INSPECTION REPORT
Sedimentation Structure
N14-Q
Kayenta Mine
Navajo County, Arizona

for
PEABODY COAL COMPANY

Dames & Moore
10139-011-22

**SITE PLAN
N14-Q**

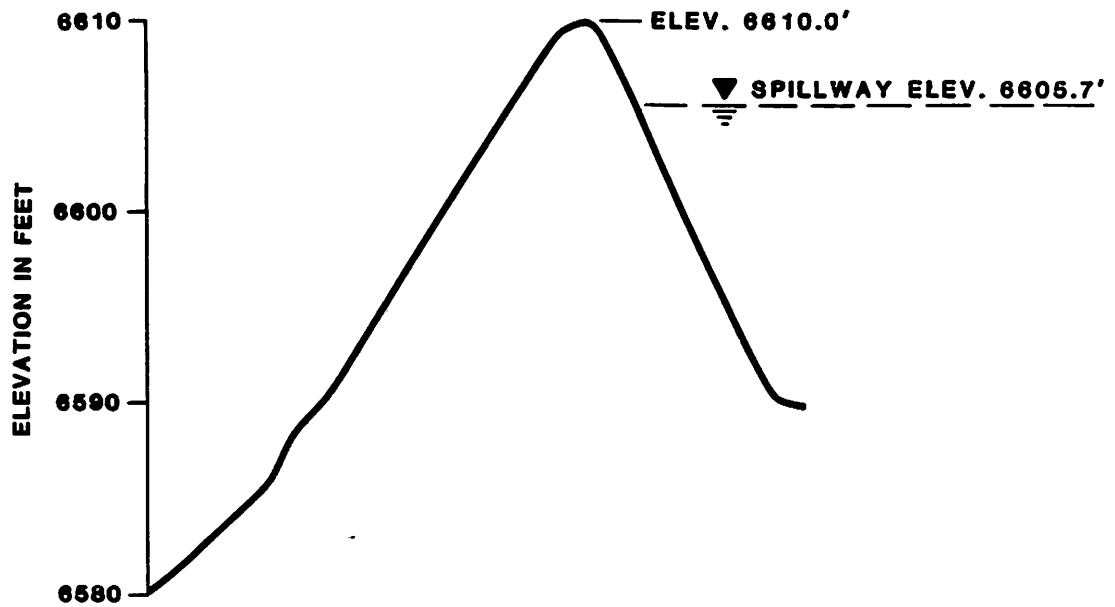
The storage capacity and spillway capacity of Structure N14-0 are adequate; however, the spillway outflow channel does not have adequate erosion protection. A trapezoidal outflow channel and a stilling basin should be constructed along the alignment B-B' shown in Plate 1. The channel and stilling basin profile is shown in Plate 4 and the required dimensions are shown in Plate 5 and Plate 6. The outflow channel and stilling basin should be protected against erosion using geotextile and riprap as shown in Plate 5.

EXISTING
MAXIMUM CROSS-SECTION
A-A'
N14-Q

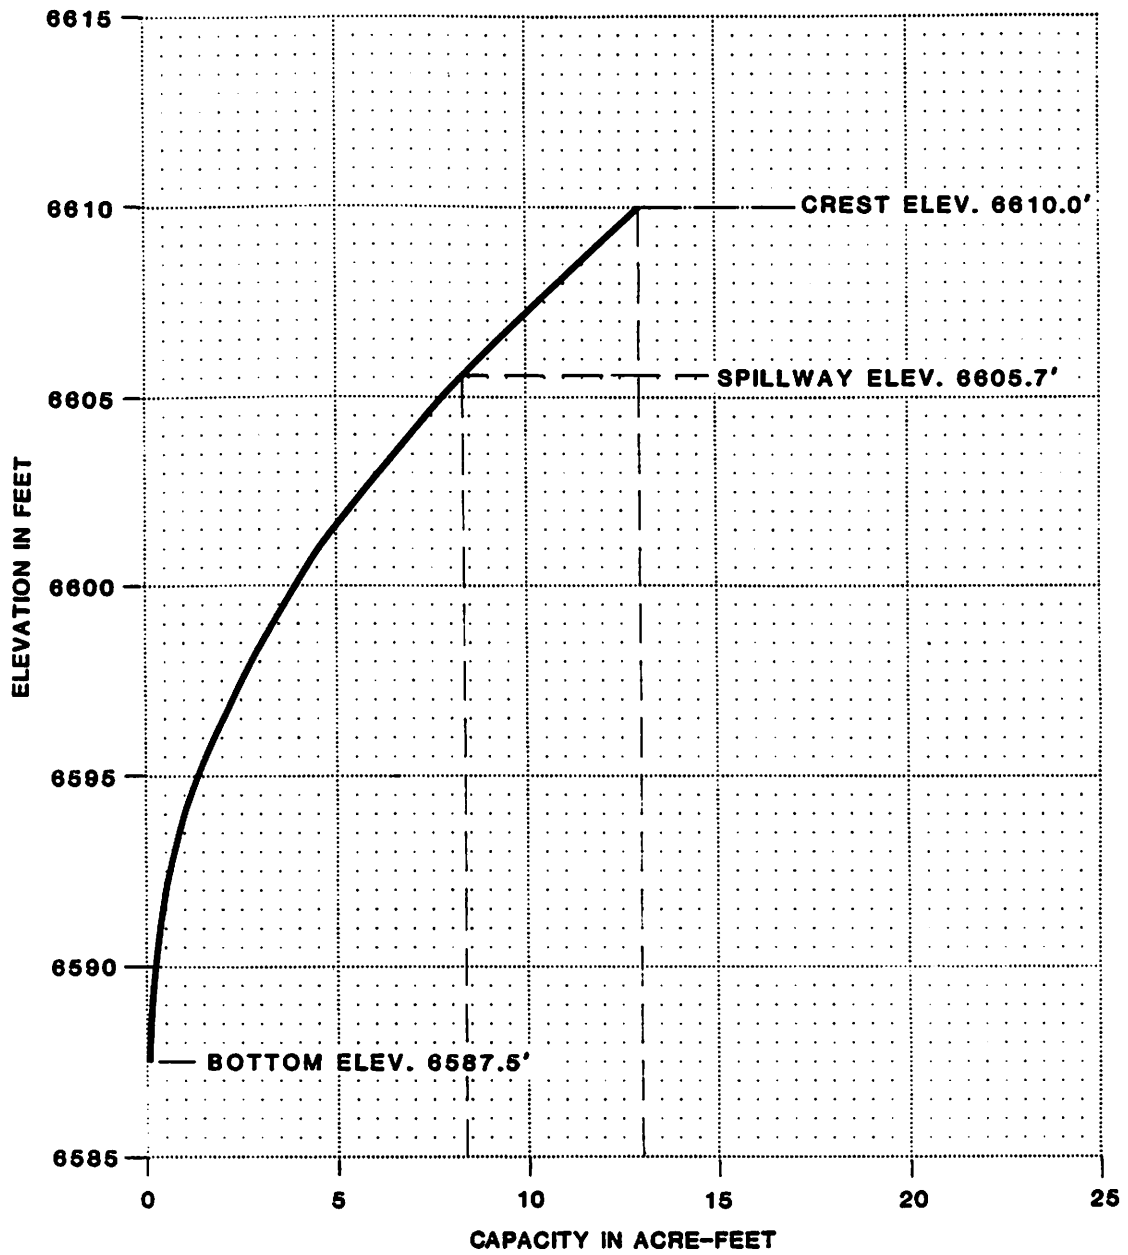
A cross-section of the embankment is shown on Plate 2, Existing Maximum Cross Section N14-Q, A-A'. Grass provides erosion protection on the upstream and downstream slopes of the embankment.

The N14-Q embankment is lower in height; however, the downstream slope is steeper than the category standard; therefore, the embankment has factors of safety less than the design minimum.

small sinkhole (3-foot in diameter and 18 inches deep) upstream of the embankment adjacent to the left abutment. Correction of erosion is considered a periodic maintenance task and does not require remedial action. The downstream slope should be flattened to 4.0 horizontal to 1 vertical to meet stability requirements. The sinkhole should be excavated to determine the extent of the cavity and then backfilled with a cohesive material. Future inspections should note any changes in the condition of the bottom in the vicinity of the repaired section.

**SPILLWAY AND
 OUTFLOW CHANNEL
 CROSS SECTION
 N14-Q**

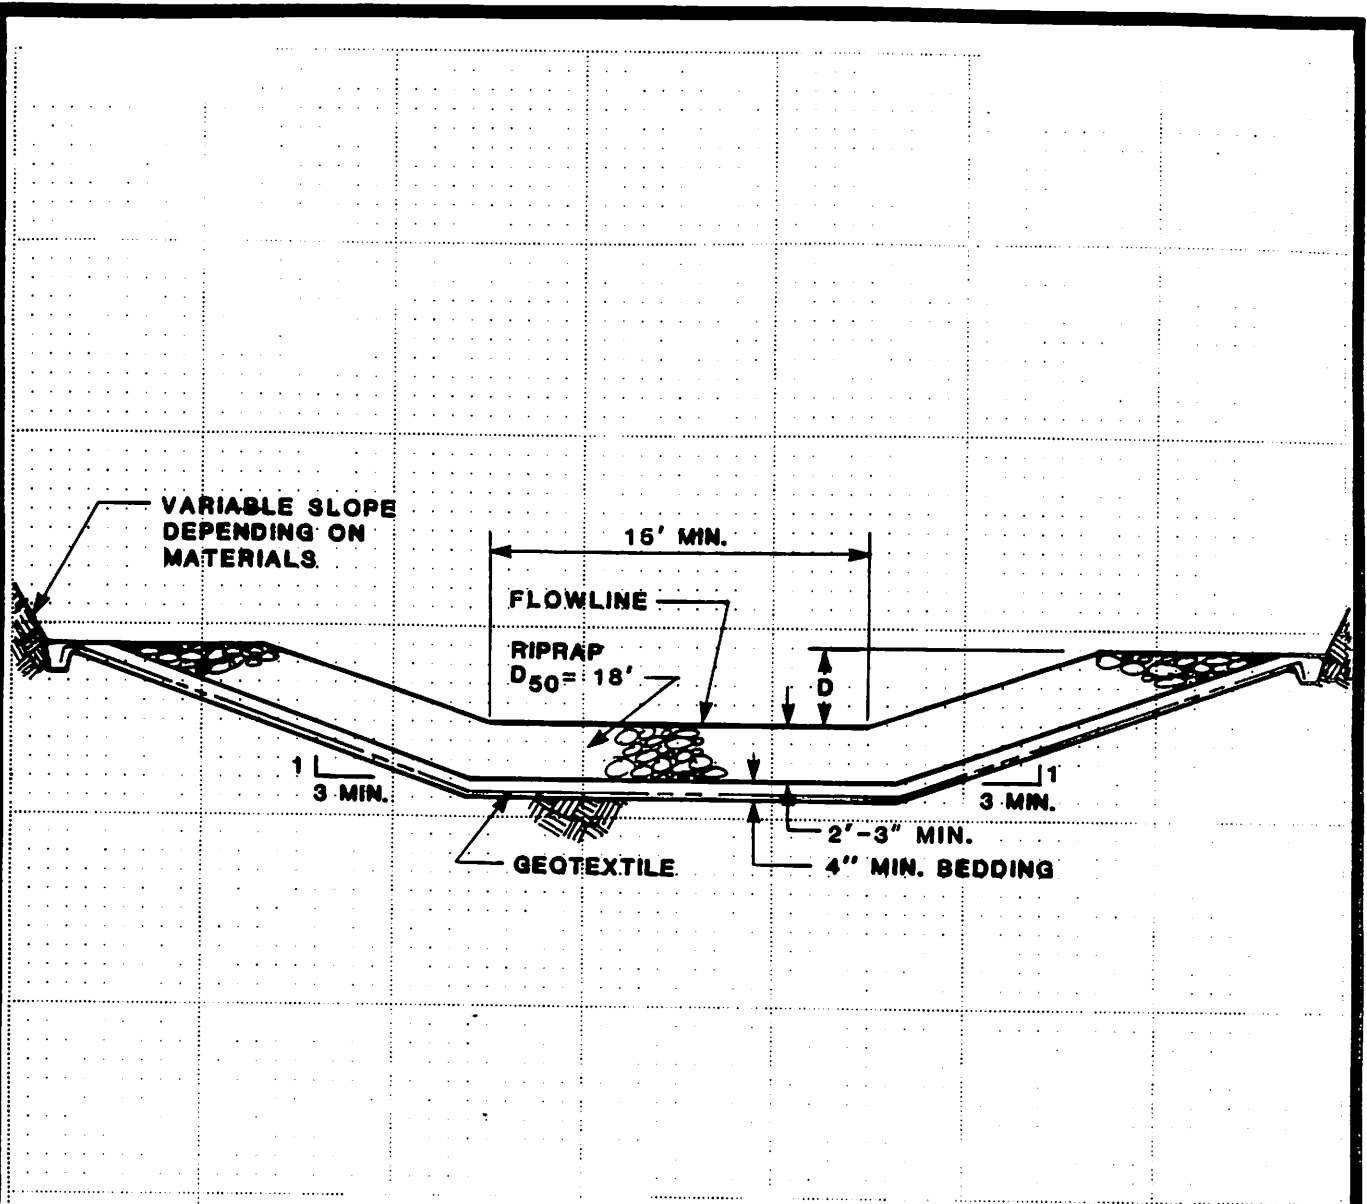
The present rock size of D50 of 10 inches is not adequate for the calculated outflow velocity and therefore does not provide adequate erosion protection within the channel.
